Land at Cranesfield, Sherborne St John, Basingstoke

Hampshire County Council Comments Response Technical Note

Document Reference: WIE18375.105.R.5.1.3.TN2 - Rebuttal

- 1.3. The purpose of this Technical Note is to respond to the further comments received from HCC Highways Development Planning, dated 2nd January 2026 (document ref: 058797), appended in full to this note.

Title
**Proposed Layout
Swept Path Analysis
Refuse Collection Vehicle**

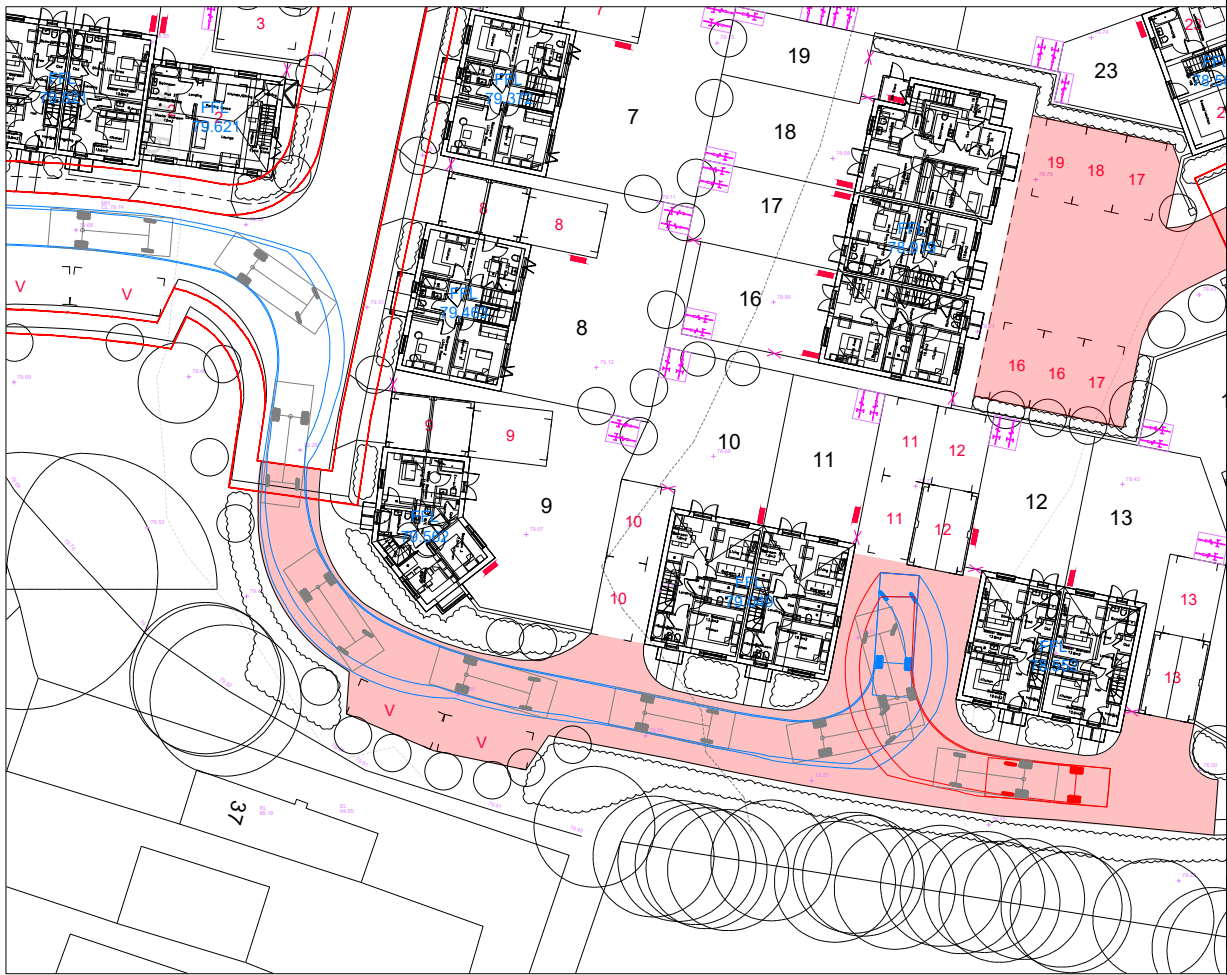
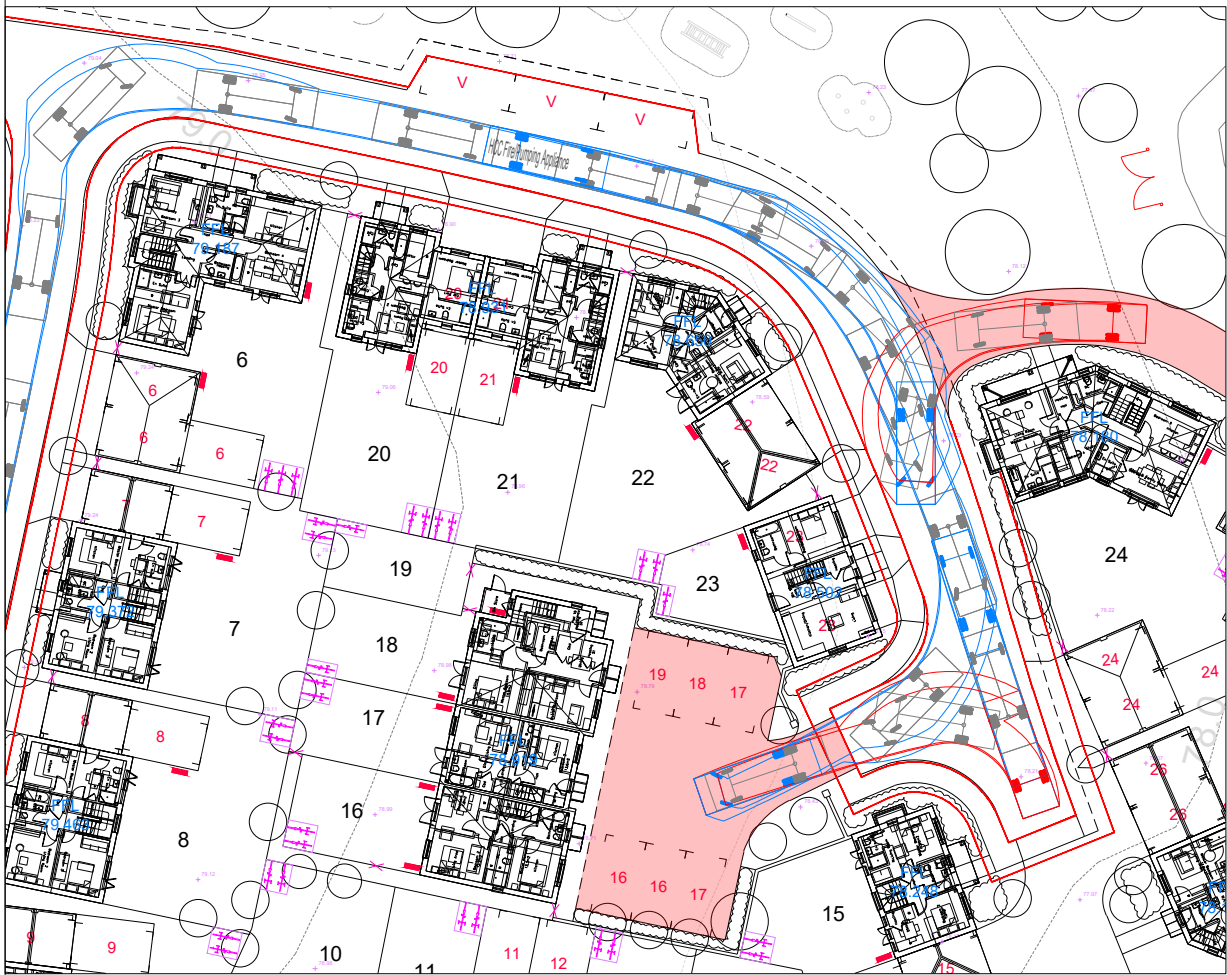
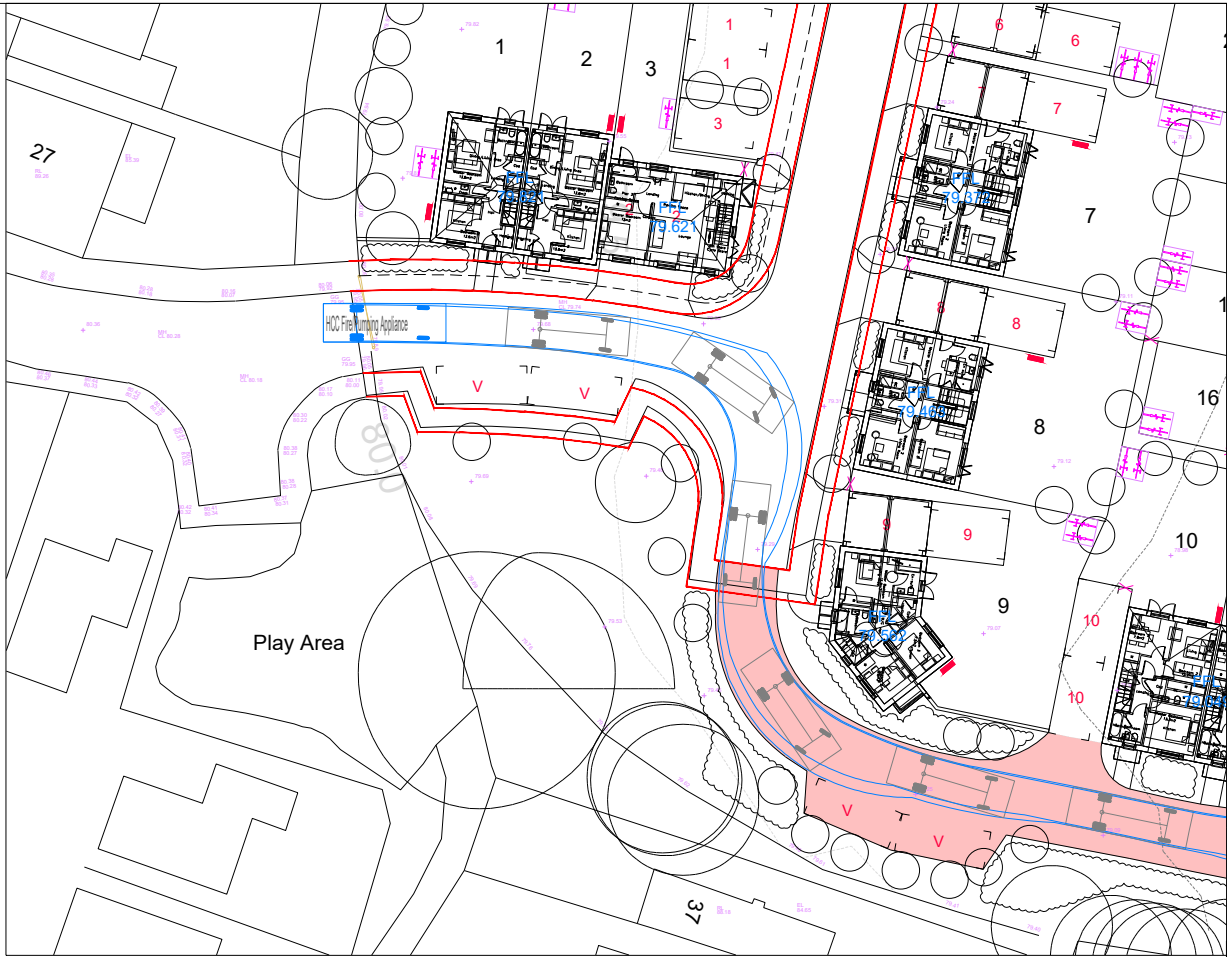
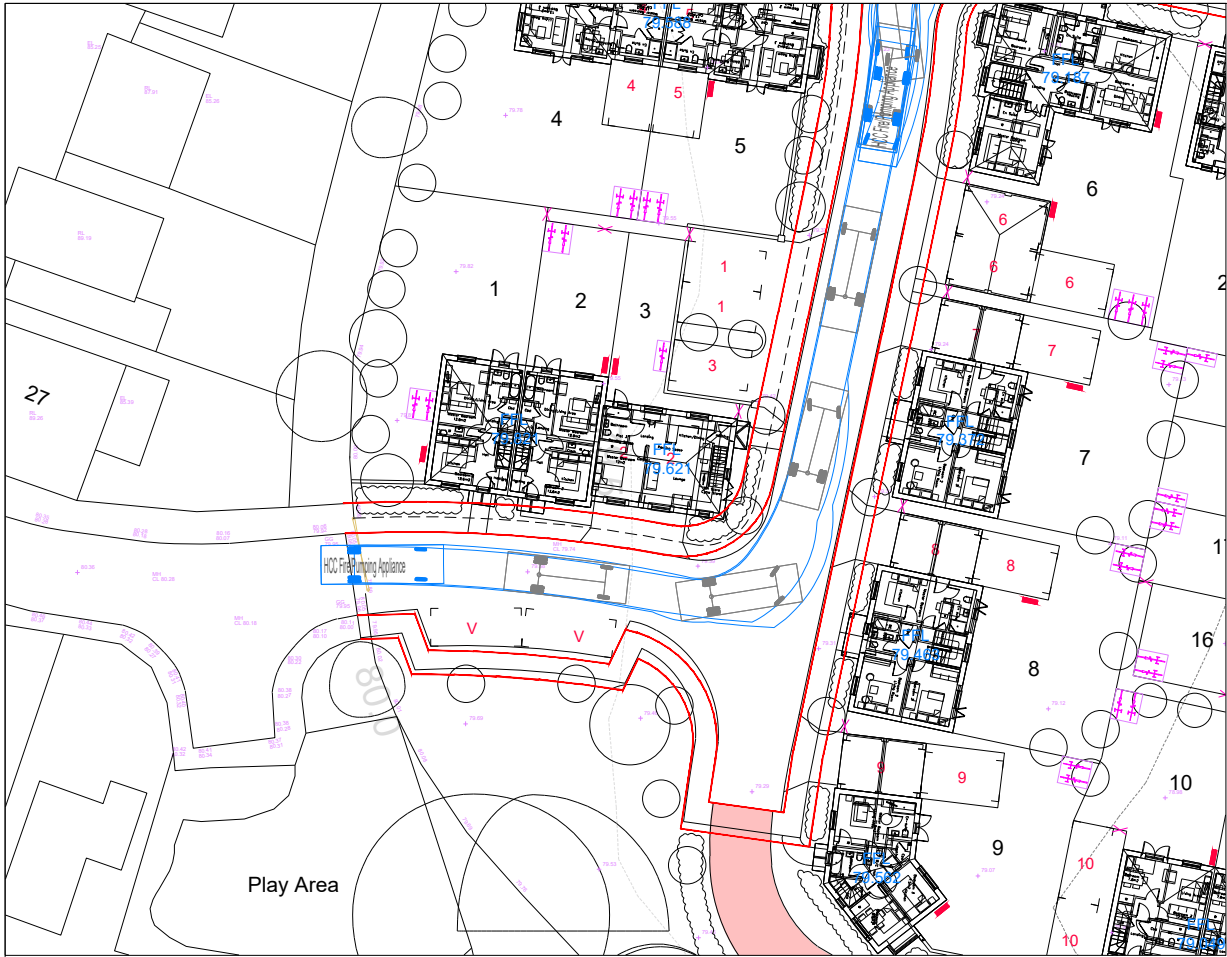
The refuse vehicle matches the TG2 design vehicle, however in general, the tracking is very tight, often touching the kerb line in areas, and leaves no buffer or margin for error.

- 2.12. The refuse collection manoeuvre described above (and identified in the image included within the HCC comments) is not considered out of the ordinary, with refuse vehicles often overhanging the edge of carriageway when making manoeuvres but the wheels remain within the extent of the carriageway when safe to do so.
- 2.13. Given that refuse collection with a vehicle of that scale occurs once per week, the resulting potential for safety issues and conflict is limited.

- 2.15. Again, the refuse collection manoeuvre described above (and identified in the images included within the HCC comments) is not considered out of the ordinary. The frequency of the collection movements limits the potential for safety issues and conflict as a result of the refuse vehicle accessing the development site.
- 2.16. However, the adjustments to the geometries identified on the amended layout plan accommodates the movements at the turning head and adjacent to plot 8 with limited (or without) the vehicle body overhanging the edge of carriageway.

Note:
Refuse Collection Vehicle dimensions in line with guidance within Hampshire County Council's 'Technical Guidance Note TG2 - Alignment Design' (October 2025).

Car Swept Path Analysis

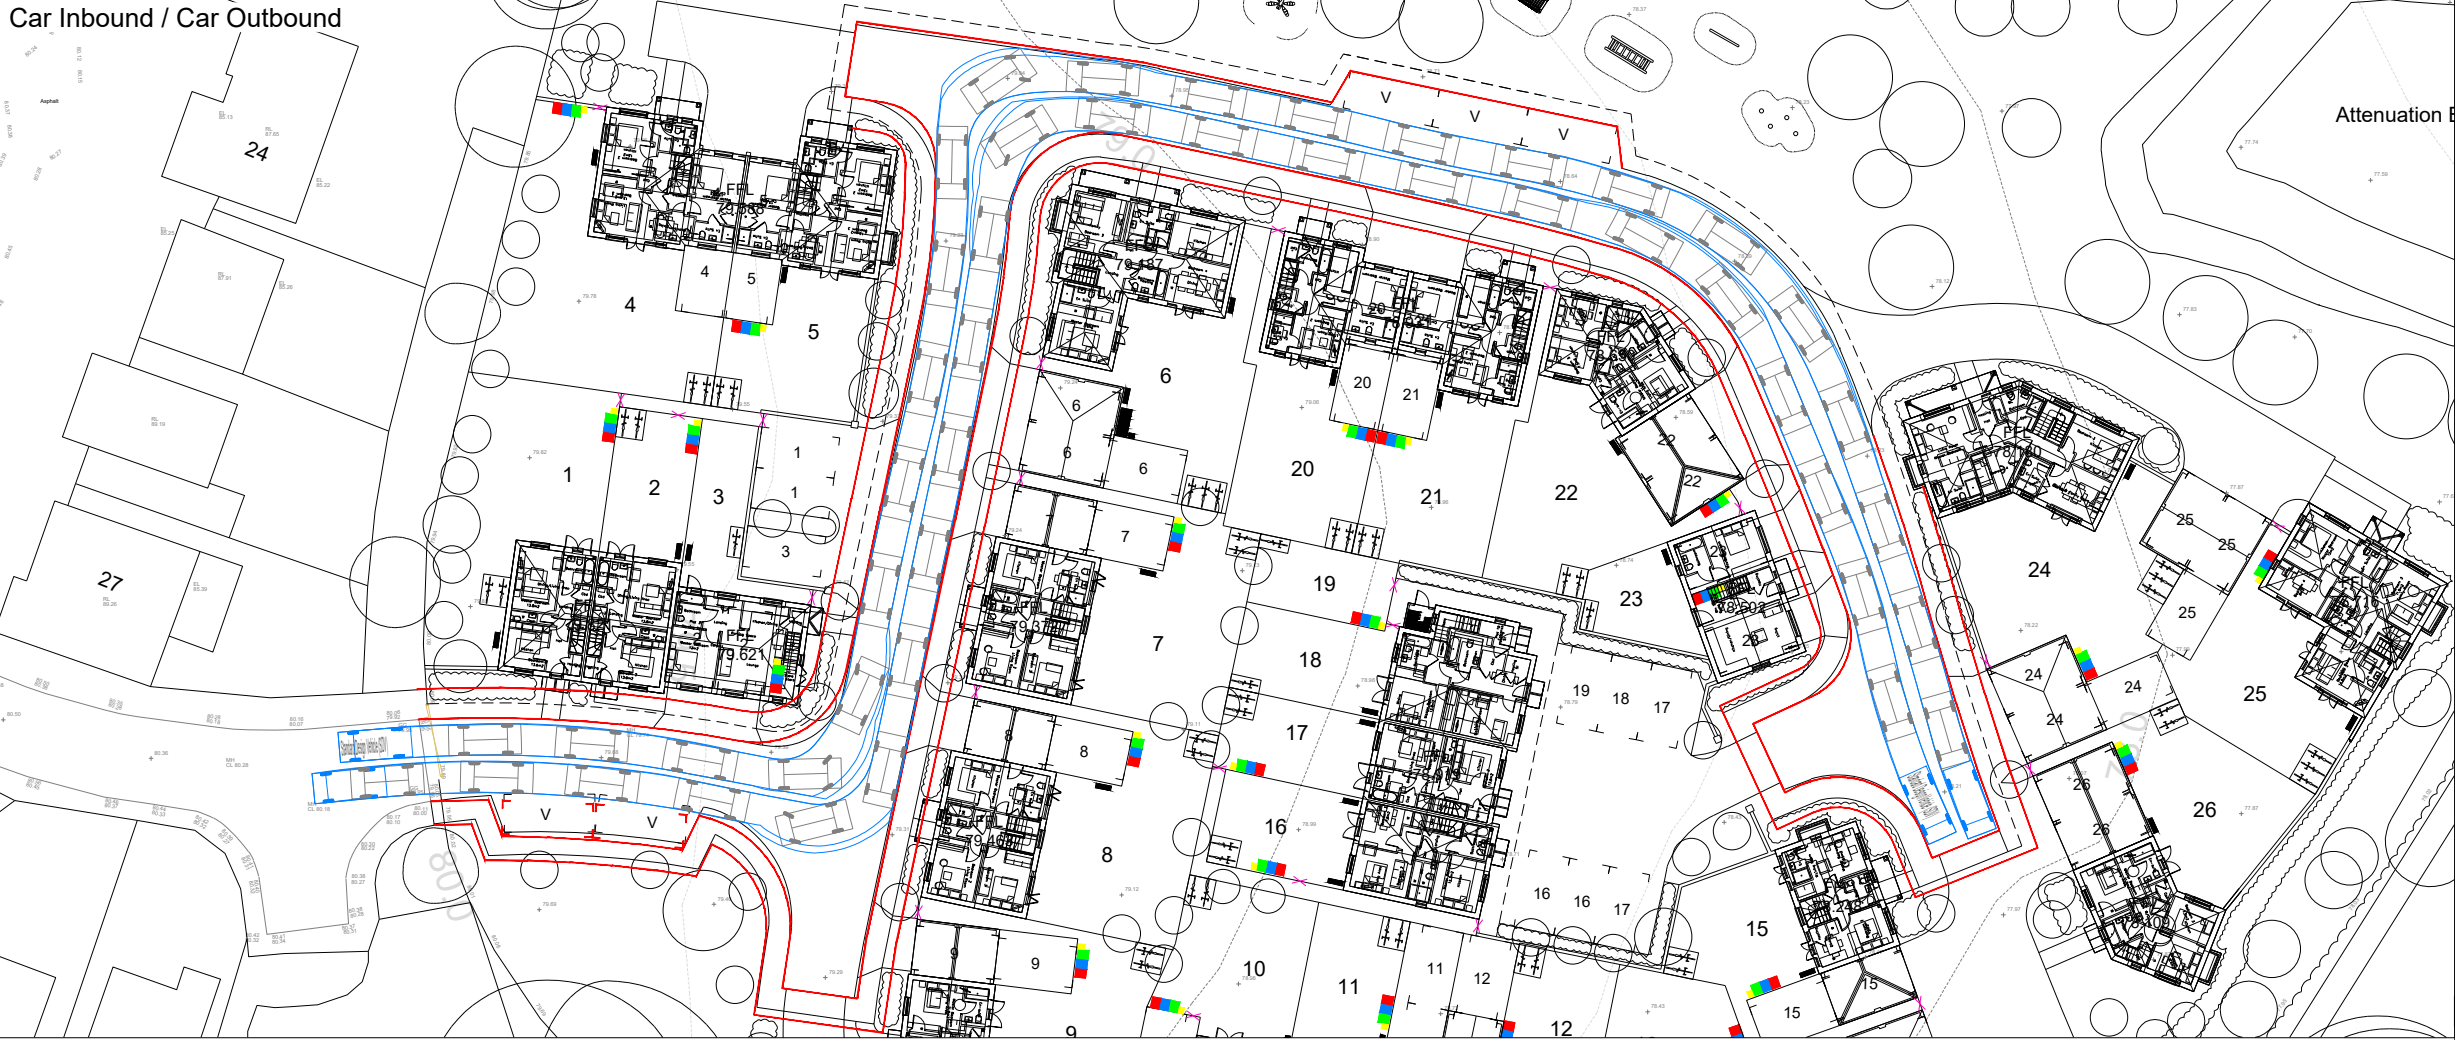
The car and van swept paths are shown separately, however, these manoeuvres should be shown together, in accordance with TG2.

- 2.17. The revised swept path plan, appended to this note, demonstrates car and van passing manoeuvres throughout the site, although likelihood of this occurring is minimal given the limited trip generation.
